PROJECT
THREE STOREY RESIDENTIAL FLAT BUILDING
WITH BASEMENT CAR PARK AT:
**5 COMMONWEALTH PDE,
MANLY, NSW**

DRAWING TITLE			PROJECT
SITE ANALYSIS PLAN			CPM
SCALE	STATUS	NUMBER	REVISION
1:500 @A3	s4.55	A0.01	s4.55

LIST OF AMENDMENTS

DRAWING TITLE		PROJECT	
DRIVEWAY SECTIONS		CPM	
SCALE	STATUS	NUMBER	REVISION
1:50 @A3	s4.55	A5.02	S4.55

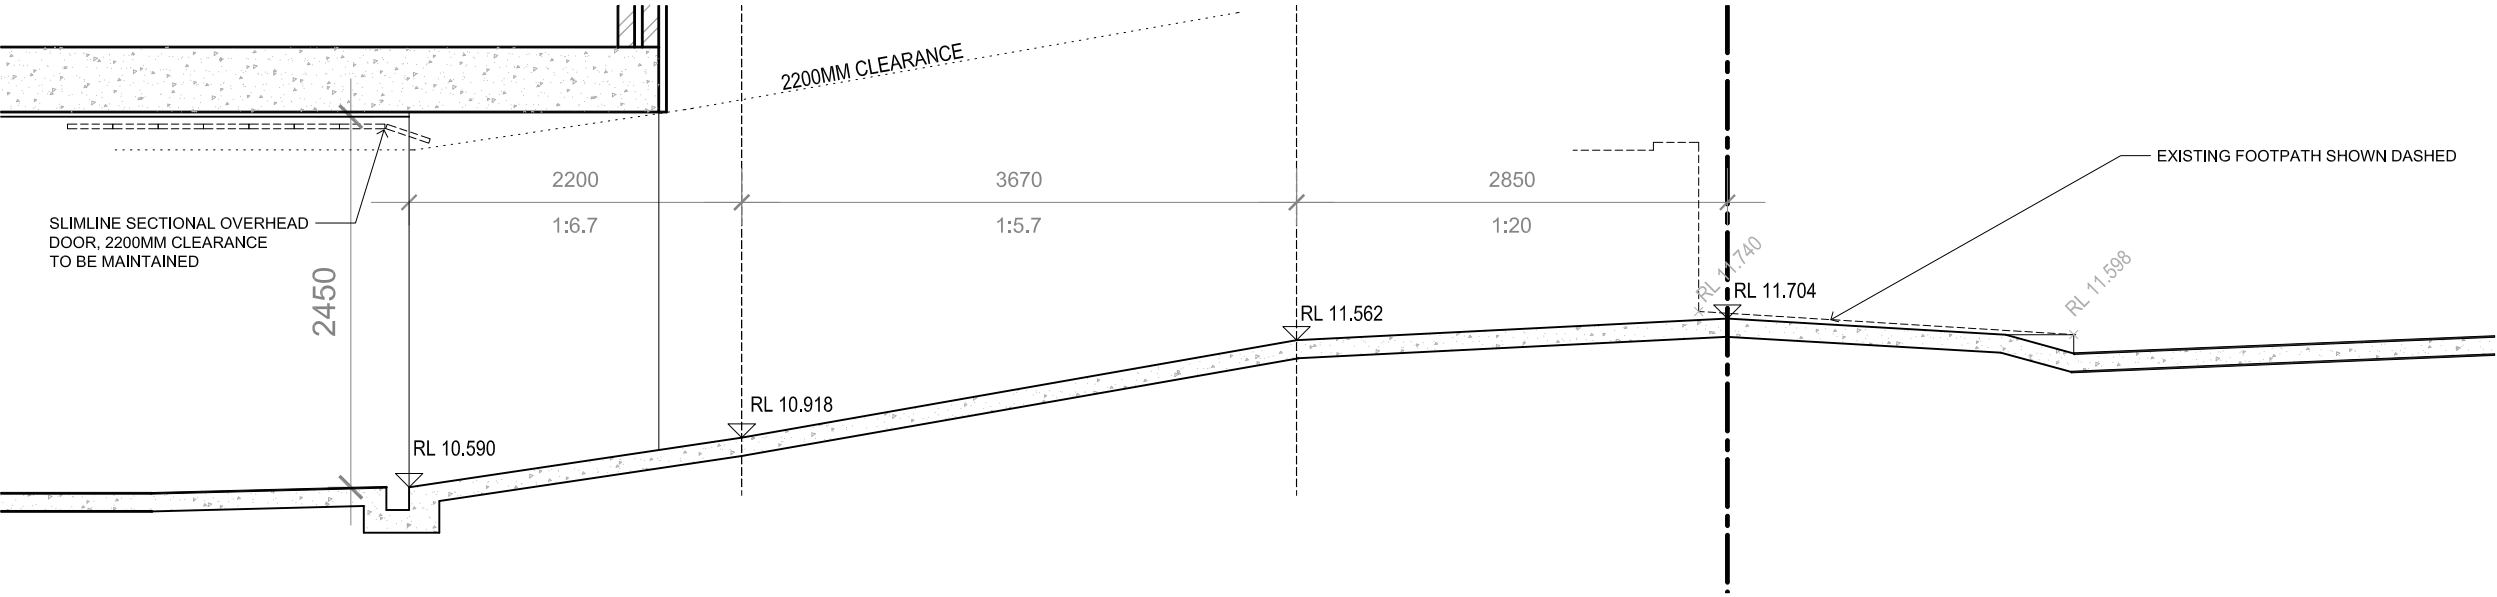
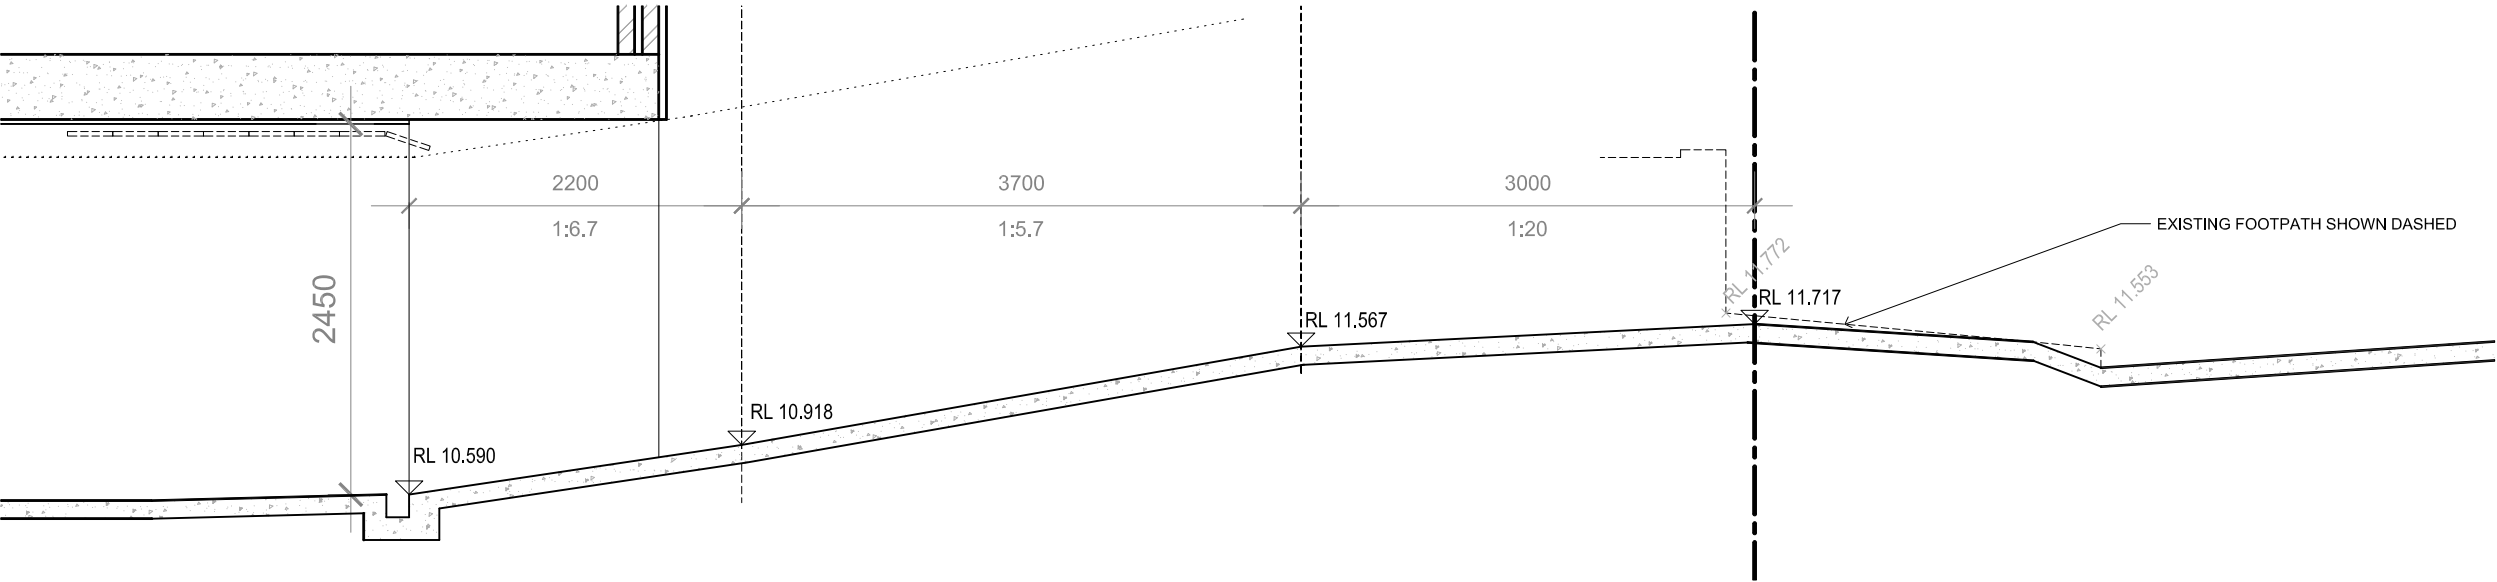
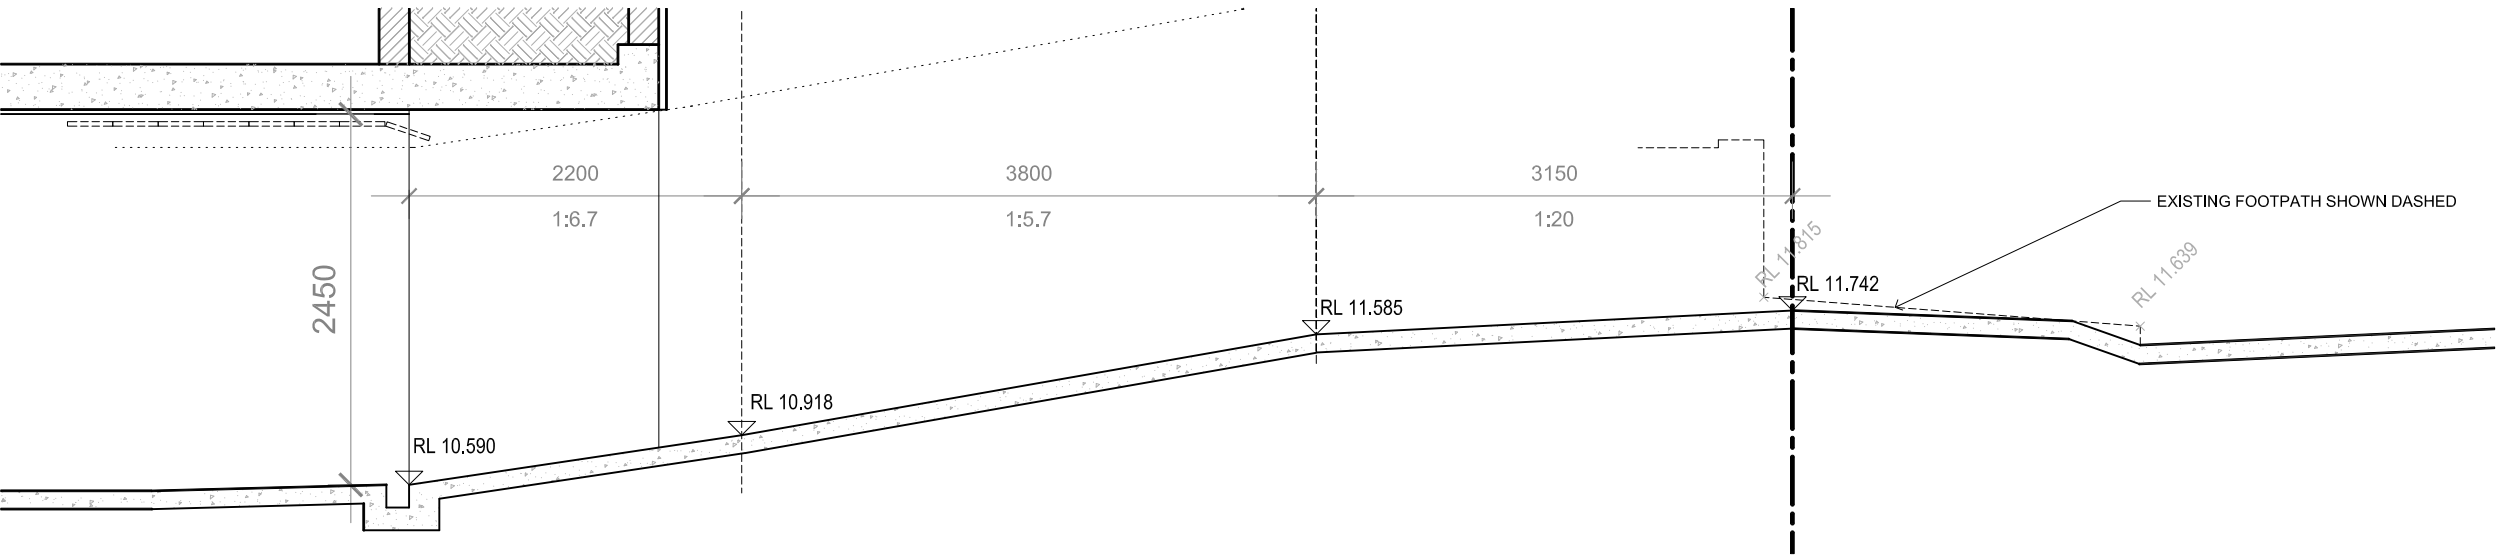
1. PREVIOUS SURVEY WAS NOT SET OUT TO AHD, ALL RLS ADJUSTED TO SUIT NEW SURVEY
2. ADJUSTMENTS TO RAMP AND CAR STACKER TO COMPLY WITH REGULATIONS & AS2890.1
3. GREENERY & PRIVACY TREATMENTS INCORPORATED INTO THE BUILDING DESIGN TO ADDRESS PRIVACY AND IMPROVE AMENITY
4. RECONFIGURATION OF THE CORE
5. INCREASED UPPER FLOOR SET BACKS AND NEW FLAT ROOF WITH NO FURTHER IMPACT ON NEIGHBOURS' VIEWS
6. GENERAL AMENDMENTS TO THE EXTERNAL APPEARANCE OF THE BUILDING AND TO THE INTERNAL LAYOUTS AS A RESULT OF PREVIOUS CHANGES
